SUBJECT: TECHNICAL ASSISTANCE REQUEST: MERCK & CO.,
INC.; RELEASE OF INCINERATOR ASH AS NORMAL
WASTE PURSUANT TO 10 CFR 20.302.

REQUEST FOR TECHNICAL ASSISTANCE

LICENSEE: MERCK & CO., INC. LICENSE NO. 29-00117-06

RE: License No. 29-00117-06
Docket No. 030-14680
Control No. 114240

SITE PLAN
0 500

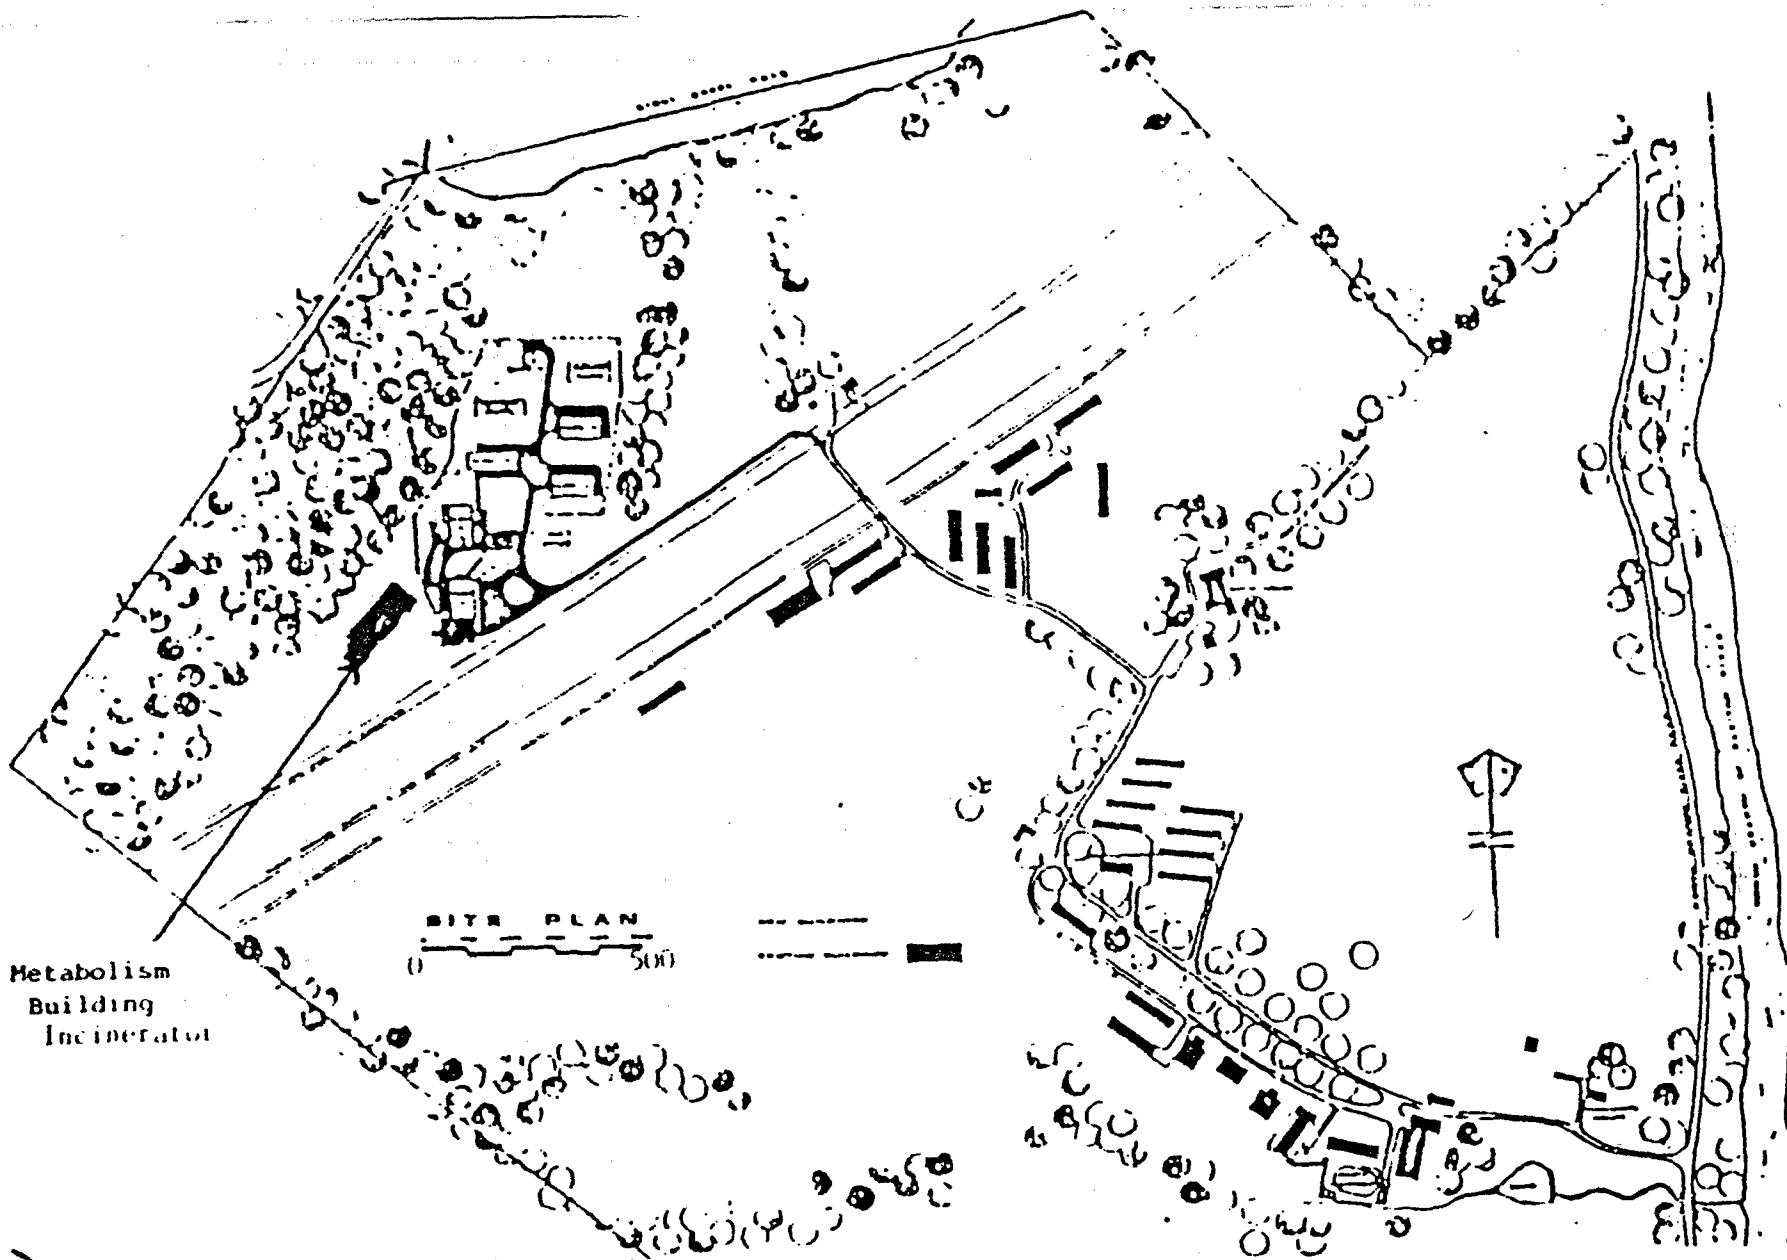
2. Submit a simple scaled drawing showing the location of the incinerator and the distance to the nearest occupied area, structure or air intake.

Please see attached drawing.
